REMARKS

Amendments to the Drawings

FIG. 3

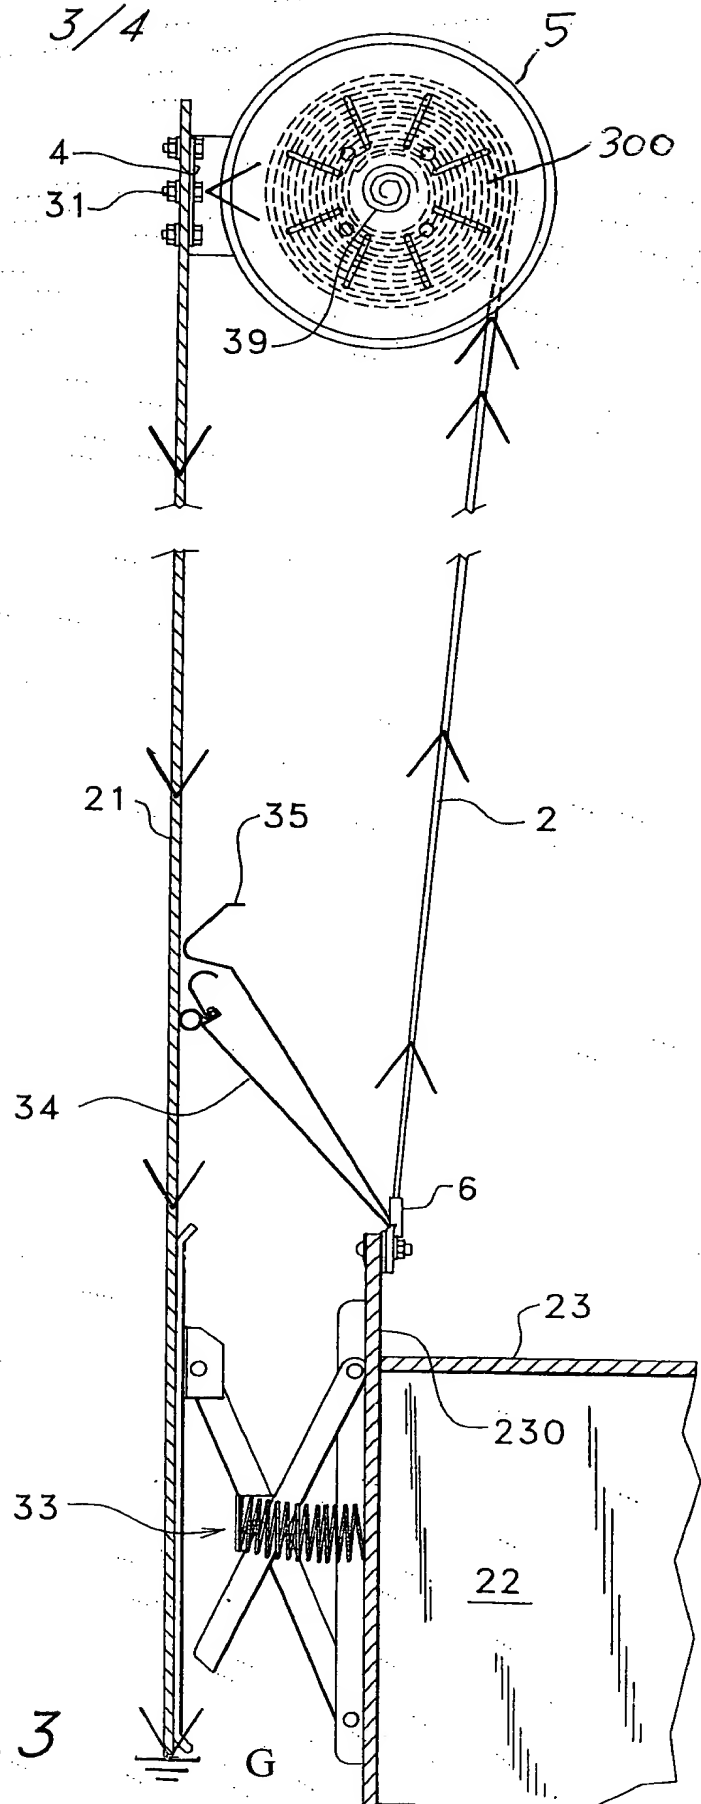
Applicants amend FIG. 3 to add reference number 5 directed to the spool and reference number 300 directed to adjacent windings. No new matter has been added – reference numbers are merely added to identify features in FIG. 3 that were present in Applicants' initial filing.

Pursuant to revised 37 CFR 1.121(d), Applicants present revised FIG. 3 labeled as “Replacement Sheet”. Changes to FIG. 3 are explained in the “Remarks” section of this amendment. No new matter has been added. Applicants also present a marked-up of copy of FIG. 3 labeled “Annotated Sheet” for the Examiner’s convenience.
